Federal, Provincial and Indigenous information requests (IRs) to Canadian Nuclear Laboratories
on the Whiteshell Reactor-1 revised draft environmental impact statement (EIS) submitted December 2022
Version 2 (revised to include comments from Sagkeeng First Nation)

May 2023

Table 2: Federal, Provincial and Indigenous follow-up information requests on the Draft Revised Environmental Impact Statement, May 2023 (Commencement of round 2 information requests)

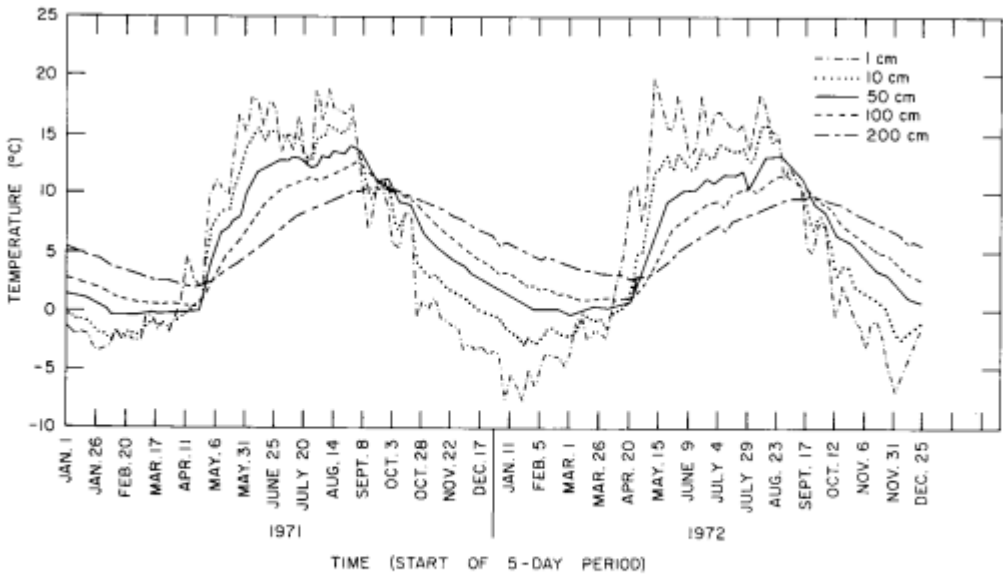
213_R2	CNSC	Section 3.4.9.1.1 and NPD and WR-1 In Situ Decommissioning Projects - Waste Form Synthesis Report	Context: In section 3.4.9.1.1 of the EIS, it is mentioned that “The ISD environment is expected to be alkaline”. Also, in Section 1.0 of the NPD and WR-1 In Situ Decommissioning Projects - Waste Form Synthesis Report, it is mentioned that “The rate of release of this inventory is expected to be low [...] because of the grouting of the facilities with cementitious materials, which results in slow corrosion rates due to the resulting alkaline conditions in the cement pore water”. Similarly, in the rest of the report, it is assumed that the grout “will ensure an alkaline environment at the surface of the metallic waste forms”. Further, in Section 3.0 of the report, it mentions that “the focus is on the general corrosion behaviour of the different metallic waste forms”, ignoring the “localized corrosion [that] may occur for carbon and stainless steel under aerobic conditions”, because “this is most likely only after the pH of the grout pore water has dropped to near-neutral values”. However, cracks, which are expected to appear in the grout very soon after pouring, will be the	CNL is to consider how (qualitatively and quantitatively) the potential local reduction in pH of the environment will affect the corrosion rates of the embedded components and how this may impact the contamination through preferential pathways of groundwater movement.	Resolved As: The Waste Form Synthesis Report (Arcadis 2021) discusses the impact of the low pH environment on corrosion rates from a general standpoint, as a means to identify the conservatism that was actually implemented in the assessment. As stated in Section 5.3 of the Decommissioning Safety Assessment Report (DSAR) (Golder 2021), “The release of contaminants from the wasteform is a slow process controlled by the dissolution of metal components. The rate of dissolution or degradation of the wasteform is dependent on the groundwater chemistry, the surface area of the wasteform and the corrosion resistance of the wasteform. For the wasteform, approach #2 (assume barrier properties are set to the most bounding conservative value in the barrier life cycle irrespective of time) was taken. The safety assessment does not examine the changes in groundwater chemistry over time, and instead uses the more conservative long term chemistry (neutral pH) as the initial condition. The release rate from the wasteform is corrosion controlled. As a result, there is no change in the wasteform release rate over time, and the release rate from the wasteform is bounded.” Change to EIS: No changes to the EIS are required in response to this IR. References: Golder. 2021. Decommissioning Safety Assessment Report for the WR-1 In Situ Decommissioning of Whiteshell Reactor 1 Project. Canadian Nuclear Laboratories Document No. WLDP-26000-SAR-001. Revision 4. December 2021. Arcadis 2021. NPD and WR-1 In Situ Decommissioning Projects Waste Form Synthesis Report. 64-508760-REPT-017. Revision 1. July 2021.
